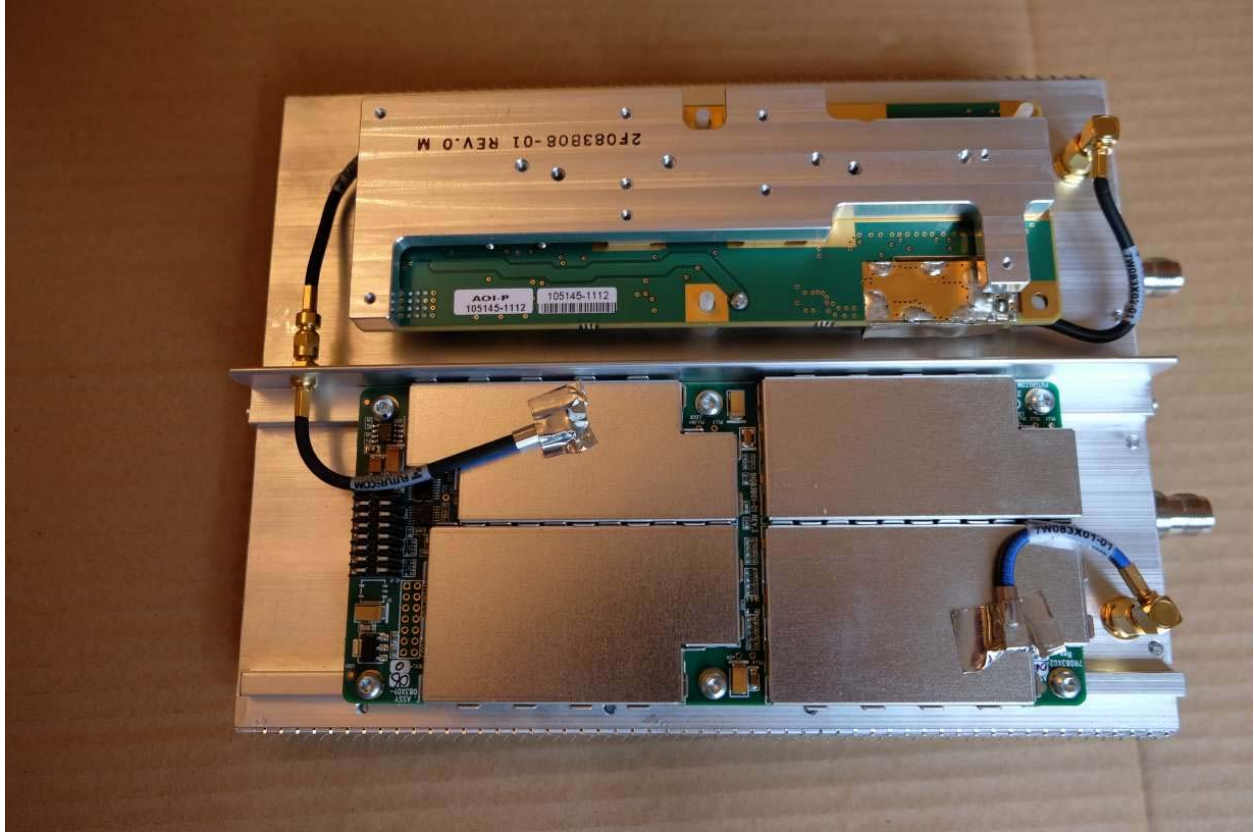
Finger stock was added on both long partition edges.

Finger stock was added on both long partition edges.

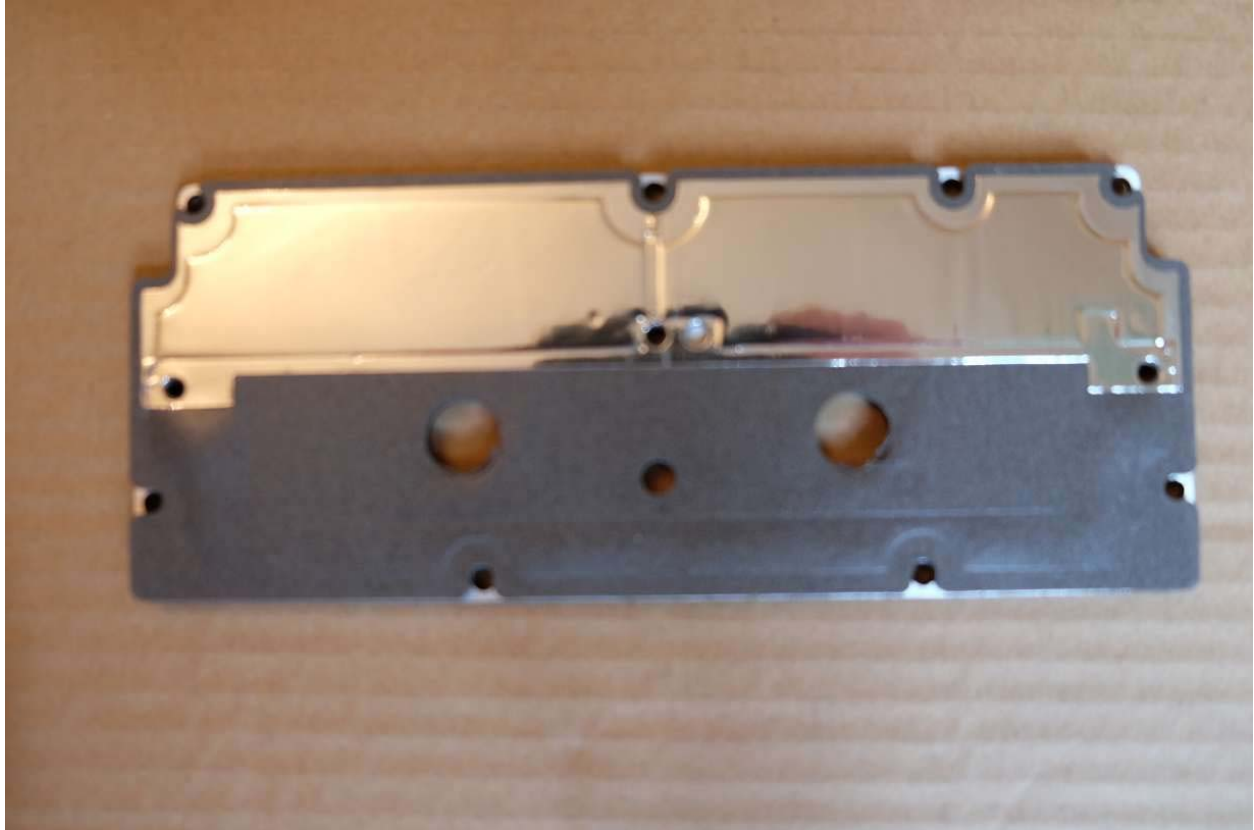
The cover is 4mm larger and the upper right screw was added

Foil was added on the EMI gasket

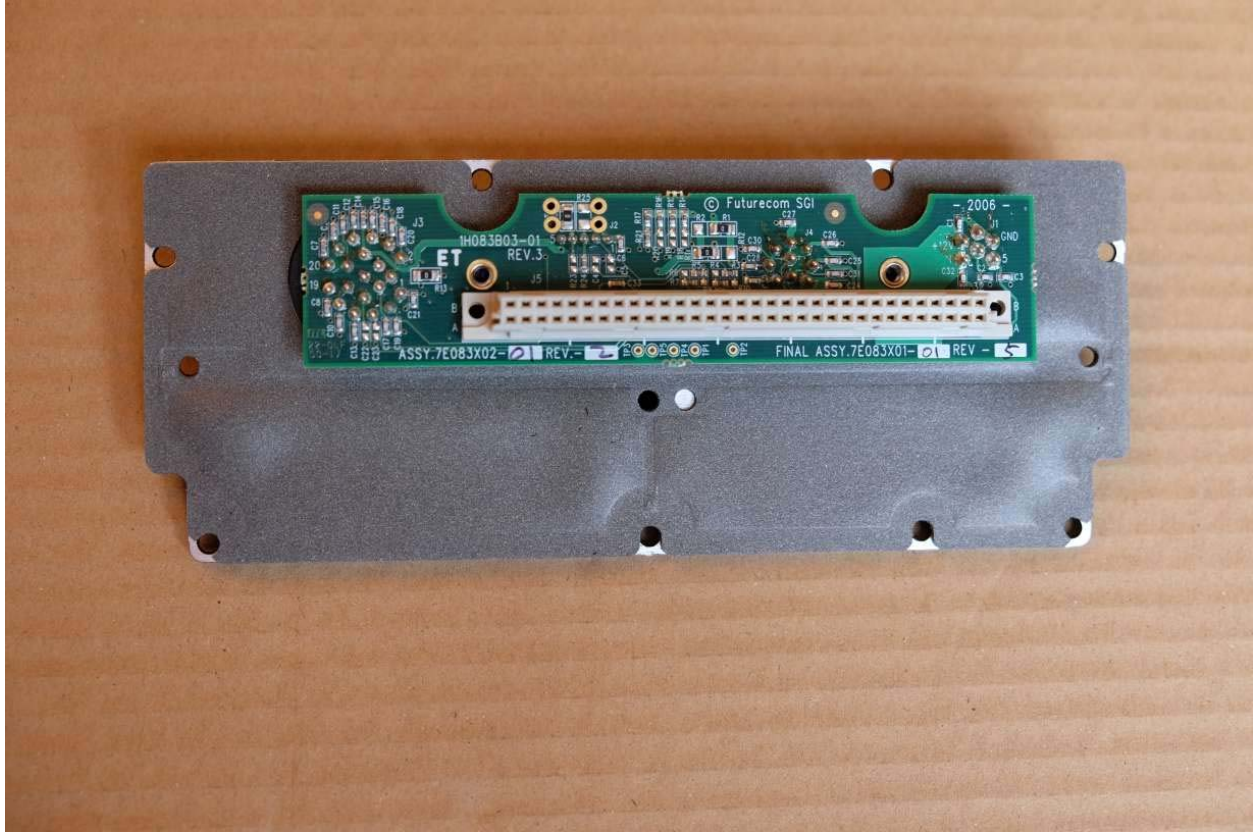
The cover is 4mm larger and a screw was added in the upper left corner.

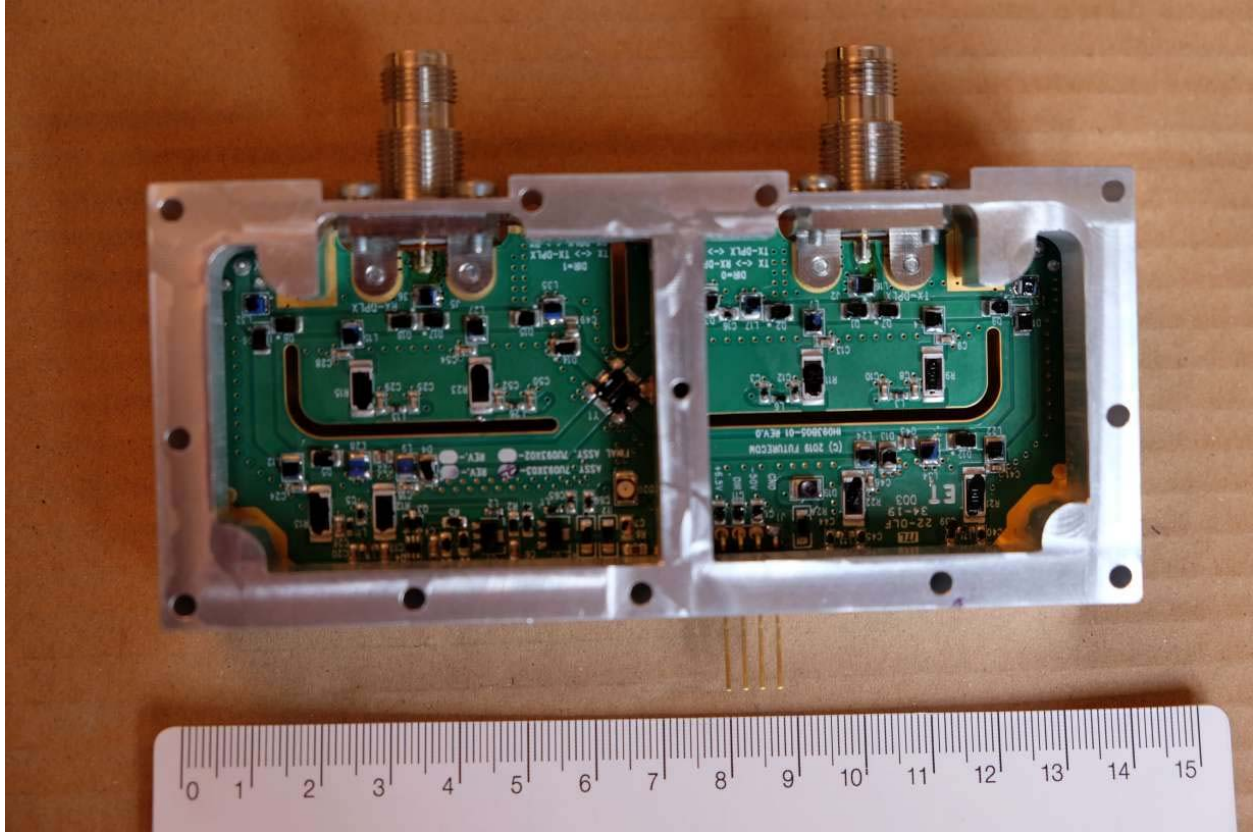
The cover now displays DVR-LX.

New TNC connectors.
